**FAA  
Flight Standards Service  
Regulatory Support Division  
Airman Testing Standards Branch**

**FAA-8083-25B, Pilot's Handbook of Aeronautical Knowledge—Addendum B**

**Figure 14-2.** Preferred Entry-Crossing Midfield.

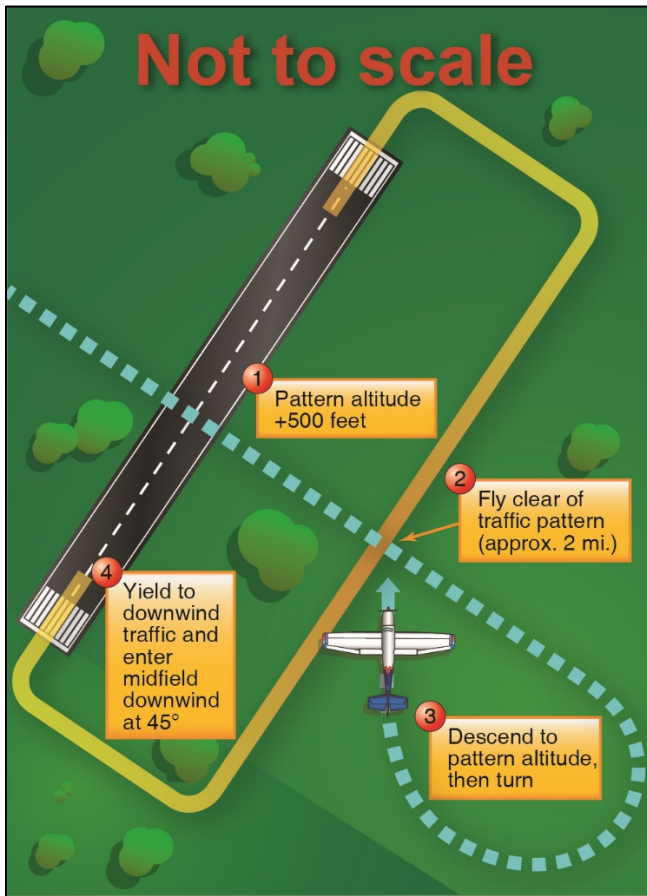
The following versions of Figures 14-2 and 14-3 will be referenced in the “Nontowered Airport” section of *Chapter 14, Airport Operations* (current figures are located on page 14-4) in the next revision of FAA-8083-25:
